Overview

The purpose of this notification is to communicate a required update to the configuration bitstreams for the Spartan-3™ FPGAs. Please update all XC3S50, XC3S1000, XC3S1500, XC3S2000, XC3S4000, and XC3S5000 FPGA configuration bitstreams using the [Xilinx ISE 6.3i, Service Pack 1 or later](#) software release.

Figure 1: Example Spartan-3 Package Markings

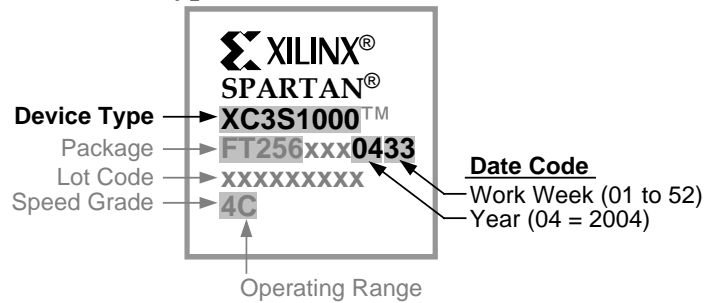
[Figure 1](#) shows an example top marking for a Spartan-3 FPGA. The relevant fields to identify an affected device are highlighted and include the **Device Type** and the **Date Code**.

Figure 2: Spartan-3 Bitstream Update Decision Diagram.

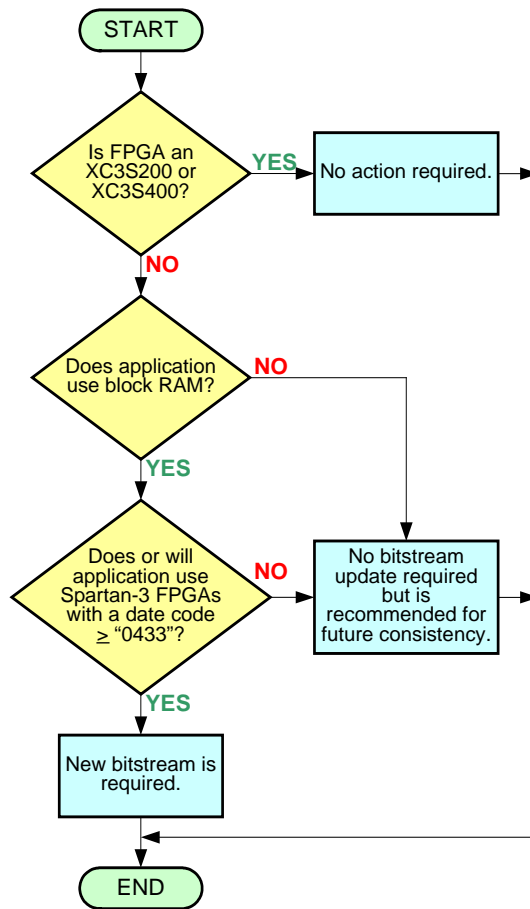
The update, however, is not absolutely mandated for all applications. [Figure 2](#) diagrams the decision process on whether a bitstream update is required for a specific Spartan-3 FPGA. No update is required for XC3S200 or XC3S400 FPGAs. Similarly, if the FPGA application does not use block RAM, a bitstream update is not required but is recommended for future consistency. Likewise, if the FPGA is not an XC3S200 or XC3S400 but has a date code prior to—*i.e.*, less than—“0433”, then an update is recommended, but not required. Finally, all XC3S50, XC3S1000, XC3S1500, XC3S2000, XC3S4000, and XC3S5000 FPGA applications that use block RAM and have or may have a date code of “0433” or later do require the bitstream update.

Xilinx recommends updating the bitstream for all Spartan-3 FPGAs using the Xilinx ISE 6.3i, Service Pack 1 software or later. By updating the bitstream, the application can use any existing or future Spartan-3 FPGA device.
